Model Communiqué

MU-300/400/400A (Hawker 400XP)

**Communiqué # 103
November, 2011**

FIGURE 2
Nitrogen Pressure Compensation Chart

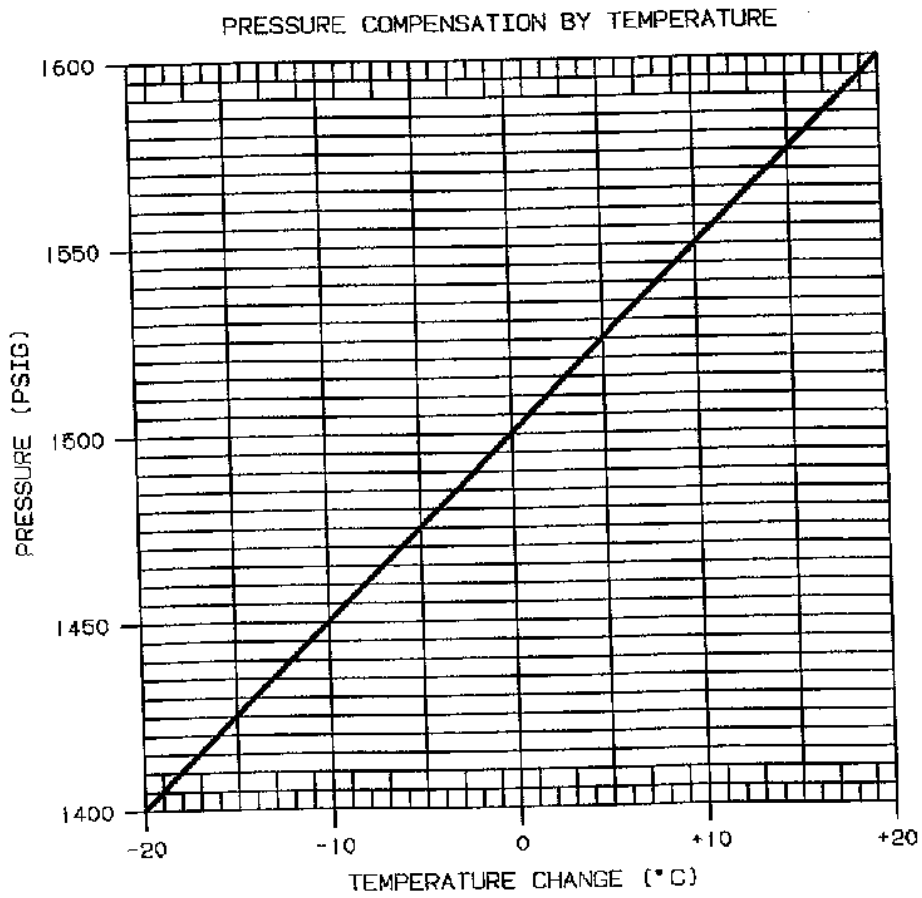
HBC's approved Type Design documentation provides for a total allowable leak rate of 25 psi in 24 hours for the emergency nitrogen system. This total allowable leak rate is based on the combination of individual component leak rate allowances such as the storage bottle, the emergency door close valve, emergency brake valve, and the system's plumbing. Nitrogen is a compressible gas and, when confined in a container, is subject to the influence of temperature. Hence, the nitrogen cylinder charge pressure can follow temperature variations. Typically, the nitrogen cylinder charge pressure can vary as much as 5 psi in pressure for every 1 degrees C (1.8 degrees F) in temperature.

When servicing the nitrogen cylinder charge pressure or troubleshooting the emergency nitrogen system for leakage, owner/operators and technicians should consider the influence of atmospheric temperature variations on the overall system status. Refer to Figure 2 for the nitrogen pressure compensation chart.

FIGURE 3
MLG Metering Tube Assembly

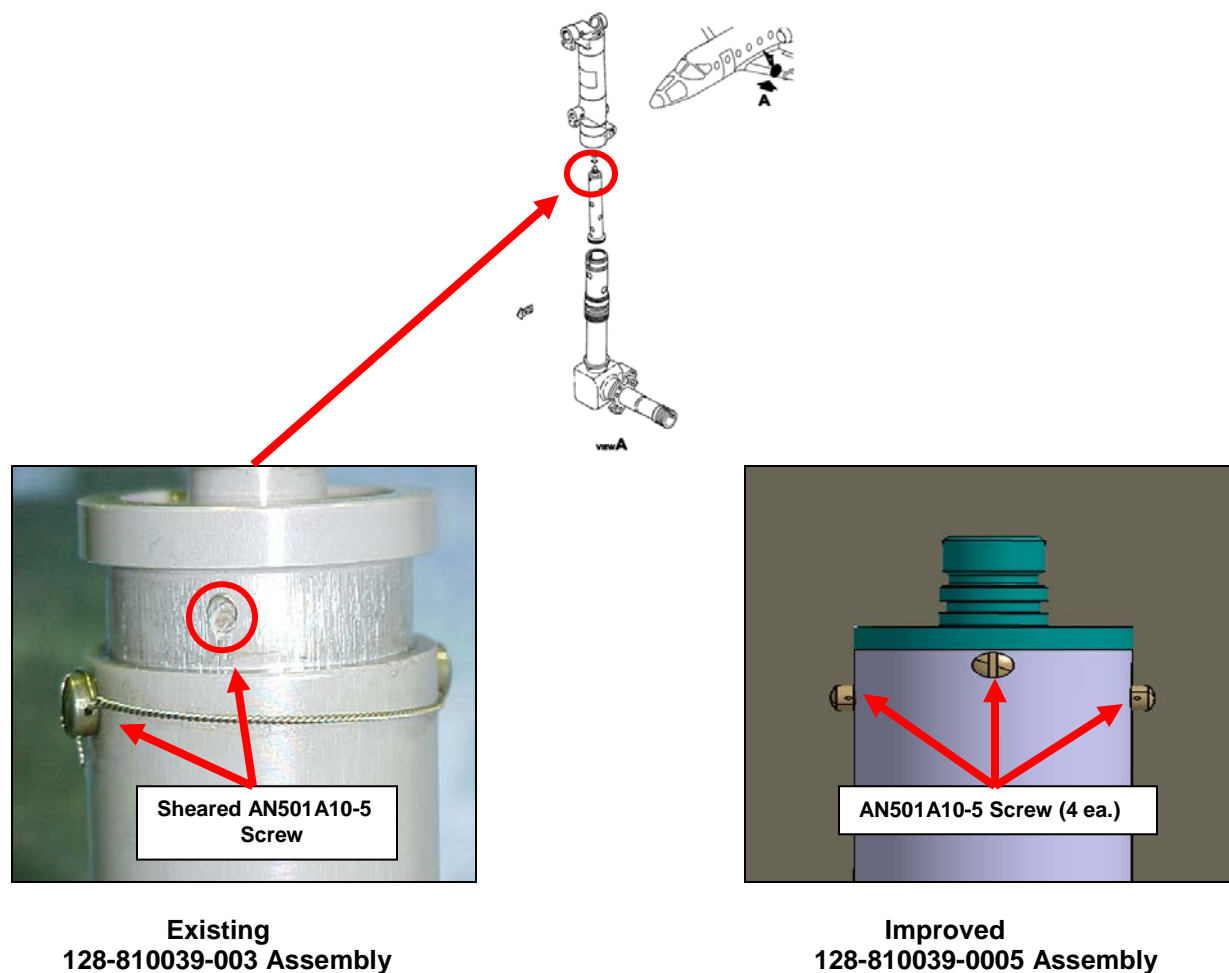
Some maintenance and overhaul facilities have discovered sheared screws (P/N AN501A10-5) in the main landing gear (MLG) metering tube assembly (P/N 128-810039-0003) installed on the Model 400A. Refer to Figure 3 below.

This condition is easily visible during disassembly of the MLG strut for maintenance or overhaul. Additionally, this condition may be indicated if the MLG lower strut will not fully collapse when checking or servicing the hydraulic fluid level per the Airplane Maintenance Manual instructions.

HBC Engineering has evaluated this condition and developed an improved metering tube assembly. This improvement incorporates two (2) additional P/N AN501A10-5 screws and increases their edge distance for better support. The new metering tube assembly, P/N 128-810039-0005, is HBC approved as a spares replacement for P/N 128-810039-0003 metering tube assembly. Parts are available through Hawker Beechcraft Parts & Distribution (HBP&D) at 1.888.727.4344 (International +1.316.676.3300) or at www.hawkerbeechcraft.com/parts.

Figure 1A

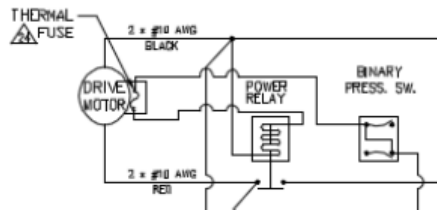
Splice in motor thermal fuse into control circuit per the following (1134400-5 Reference Figure 1A Electrical Schematic, 1134400-1 Reference Figure 1B Electrical Schematic):

1134400-5 Configuration:

Cut control lead between pressure switch and power relay (black lead) at approximate location shown in Figure 2 (approximately 2 inch from the binary switch)

Figure 1B

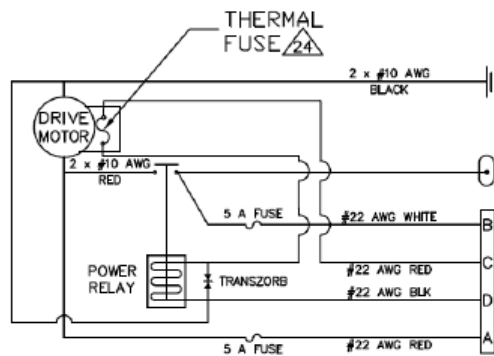
1134400-1 Configuration:

Cut control lead between Pin C and power relay and splice in thermal fuse as shown in Figure 1B.
